BIKESydney's Response to the City of Sydney's Crown Street Improvement Project

On the basis that it was passed [as presented to the 19 Aug 2013 EC meeting](#), BIKESydney submits the recommendations below for Council's consideration.

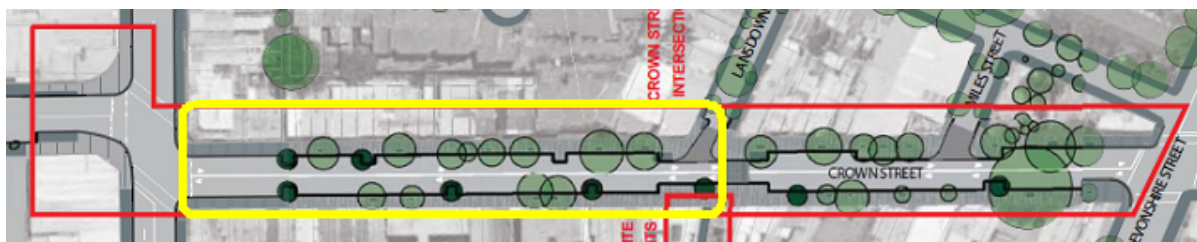
2. **Background Point 9(f)** indicates that the number of mid-block thresholds will be reduced from two to one. This will encourage higher motor vehicle peak travel speeds, and so, reduce safety for cyclists. BIKESydney can support the concept of provisioning cycling by means of an *on-road mixed-traffic treatment* on the proviso that ACTUAL (not merely theoretical) motor vehicle speeds do not exceed 40km/h. (In actuality, the City should be moving toward restricting traffic speeds to indeed 30km/h as is best practice in other world cities. What efforts are being made with the RMS to have the road rules make provision for a 30km/h road speed designation? The Crown Street Improvement project presents a prime opportunity to enable that discussion with the State Government).

As presented, the scheme will encourage faster driving (compared to the present situation) and in any case, speeds above 40km/h (despite the posted speed limit). Separately, motorists travelling north on Crown St (South) will be encouraged to overtake northbound cyclists given the now longer "uninterrupted" mid-block section between Cleveland and Lansdowne (refer figure below). (Note, northbound cyclists will be travelling uphill, and thus slower.)

The scheme should enunciate measures to ensure that travel speeds will not increase and in any case be kept below 40km/h. Even aside from consideration of cycling provision, the success of the entire scheme (pedestrian facility, shop and browse, outdoor dining etc) depends on traffic being suitably calmed. As above, there are grounds for suggesting that the scheme will result in an *increase* in peak traffic speeds. We propose that along with BIKESydney, the City investigate vehicle speeds (using a radar gun) on this section of Crown St to monitor whether even *existing* travel speeds are contained to 40km/h...
